WARRANTY BULLETIN

WB24-25

DATE :	July 2024	SECTION:	06 ELECTRICAL
EXPIRATION:	July 2026		
SUBJECT:	REPLACEMENT OF DECAL "REAR JUNCTION BOX COMPONENTS"

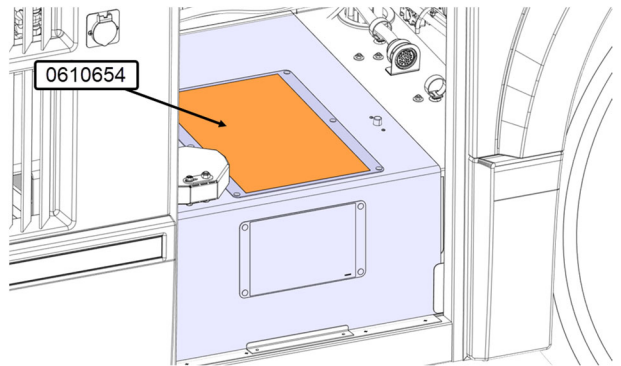
2. Remove the decal of the rear junction box components.

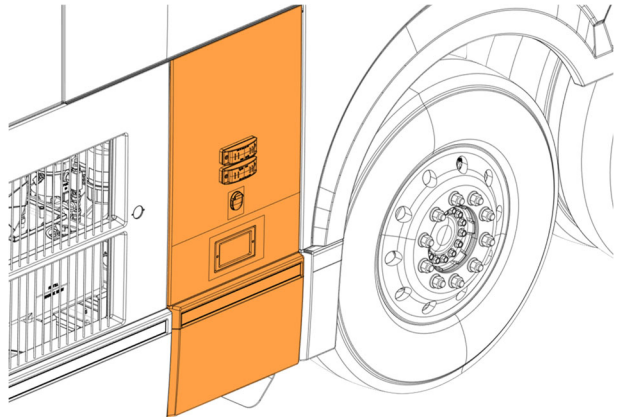
3. Install the new decal of the rear junction box components 0610654.
